Travis County Commissioners Court Agenda Request

AGENDA LANGUAGE: Consider and take appropriate action on a Variance to Title 30-2-158(B(2) Access to Streets (Requires that a new subdivision must have at least two access streets and each of the two access streets must connect to a different external street) for The Hills of Shady Hollow-Preliminary Plan.

**RE: Hills of Shady Hollow (C8J-2012-0095)
Variance Request - C.O.A. Land Development Code Section 30-2-158(B)(2)
Subdivision Access Streets**

Proposed Secondary Access

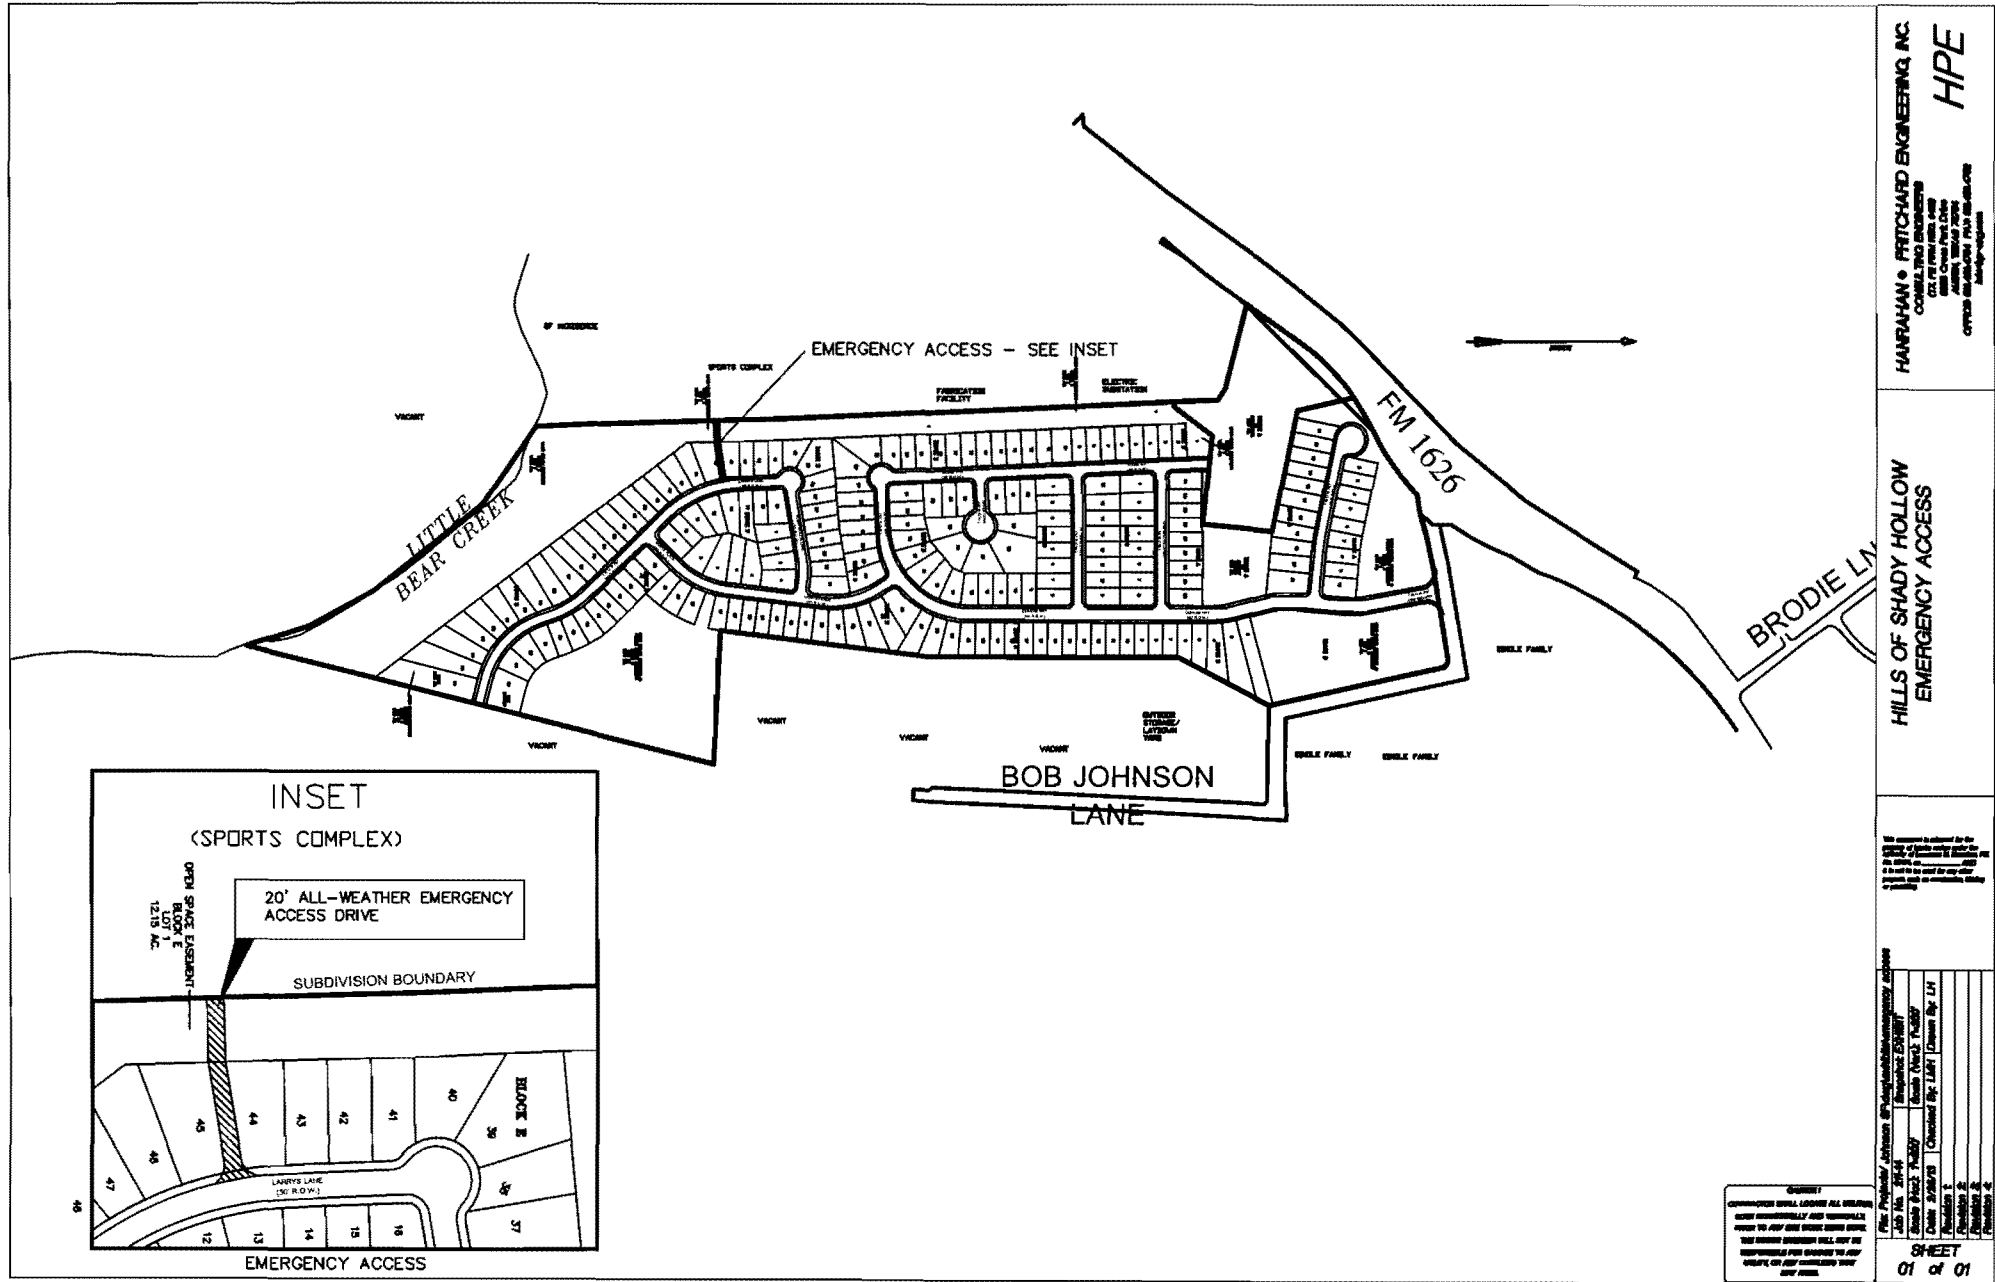
The preliminary plan proposes a second access point to an adjoining property, for use by emergency vehicles. An all-weather access road will be constructed through the access easement. Please refer to the preliminary plan for the proposed access location.

HILLS OF SHADY HOLLOW
 EMERGENCY ACCESS

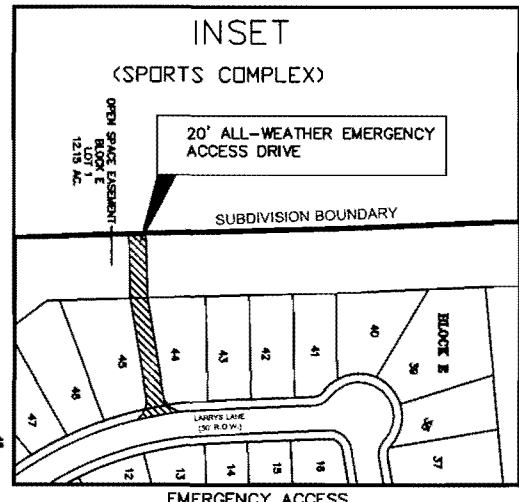
TNR staff has reviewed the applicant's request for the variance and recommends approval. The applicant has worked with the Travis County Fire Marshal's office and has satisfied all of Travis County Fire Code requirements to only have one direct connection to an external street. The applicant has proposed to provide an emergency access easement on the western part of the development. Based in part on the addition of the access easement and the proposed stub street, Hershel Lee, Fire Marshal indicates, the preliminary plan is "capable of meeting the requirements of Travis County Fire Code". The applicant proposes to acquire the access easement and will be constructed as an all-weather road for emergency purposes.

TNR staff recommends approval of the variance based in part on the Fire Marshal's review and recommendation.
